**PLAN AND PROFILE OF NOISE WALL 5B**

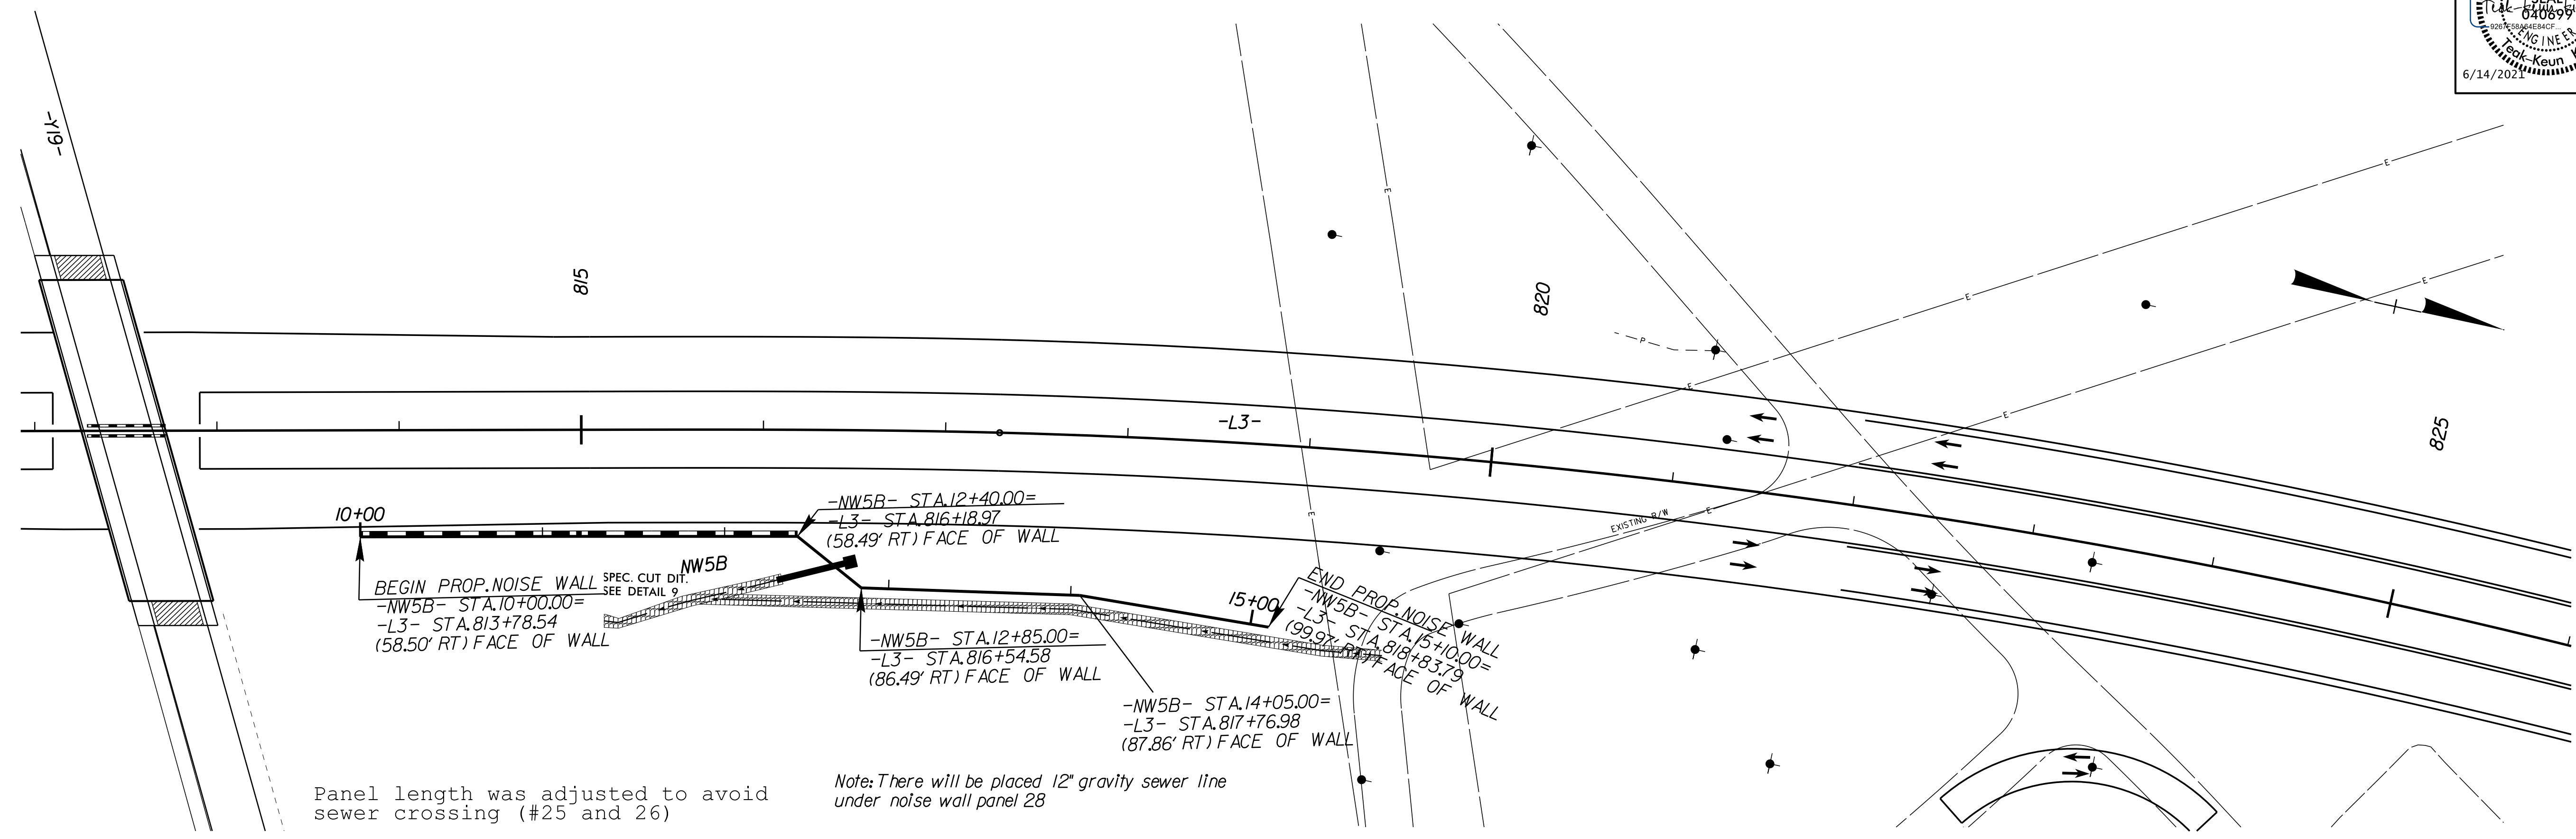
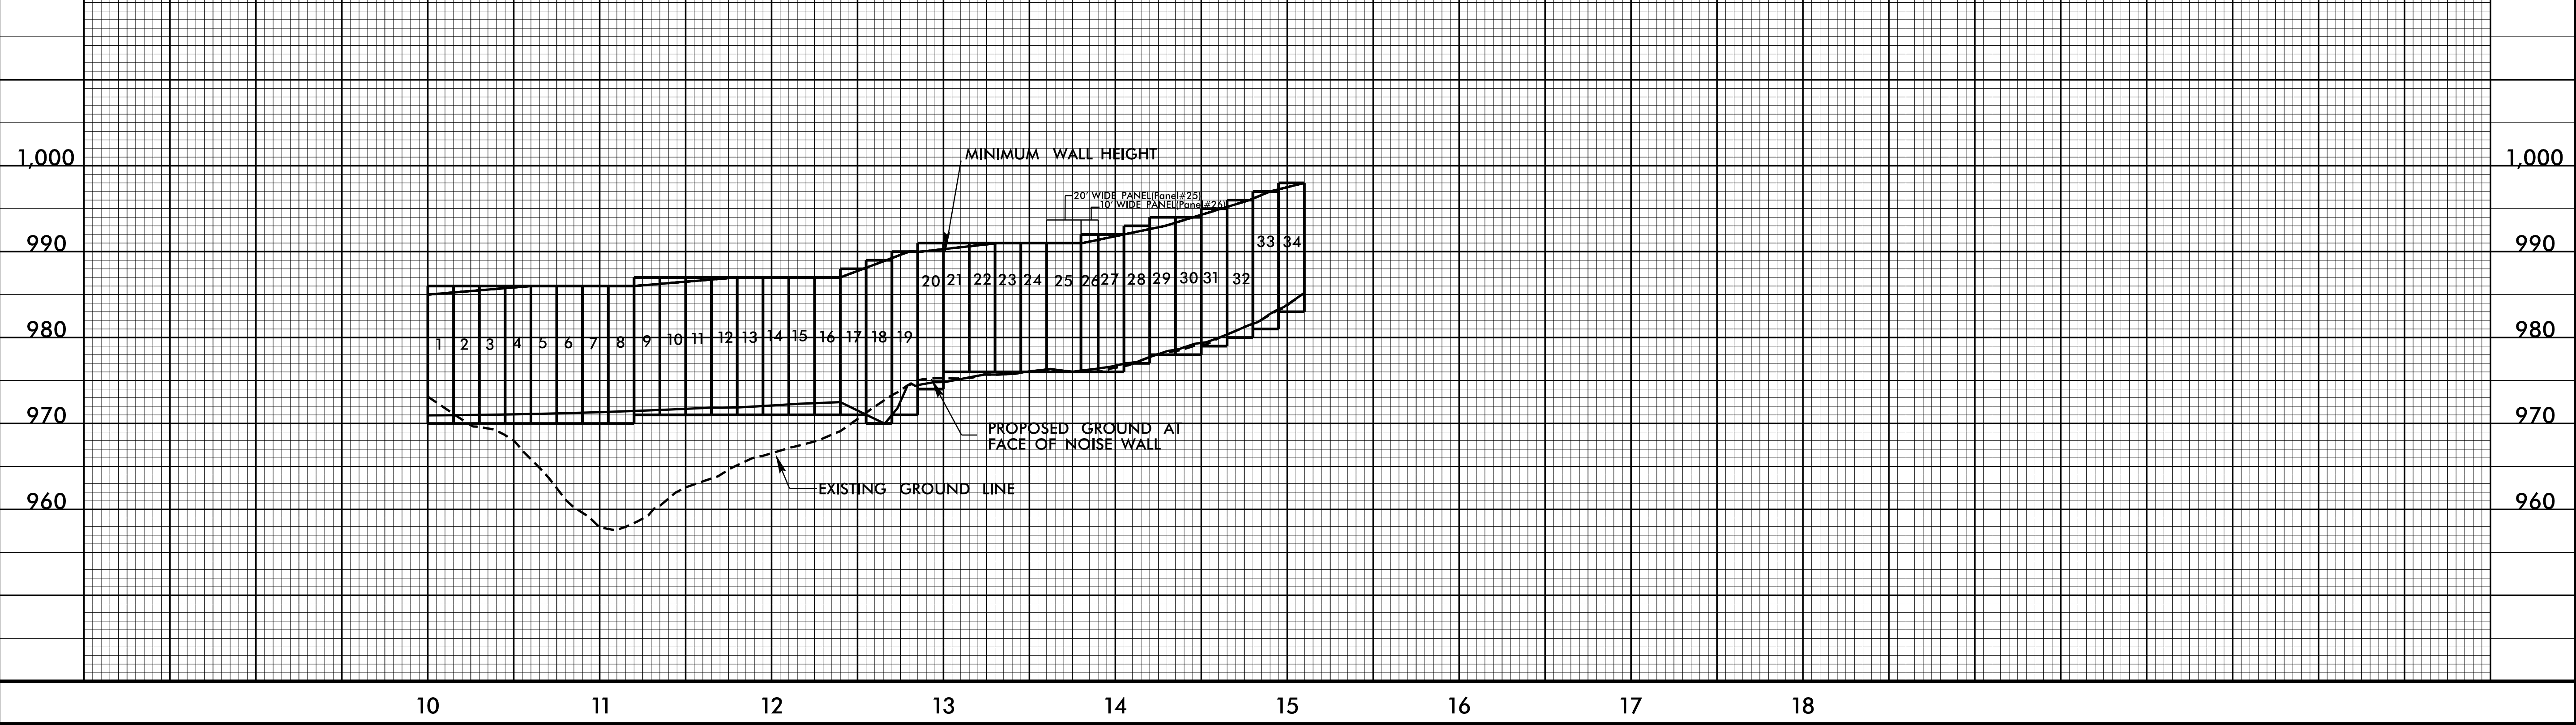
Panel length was adjusted to avoid sewer crossing (#25 and 26)

Note: There will be placed 12" gravity sewer line under noise wall panel 28
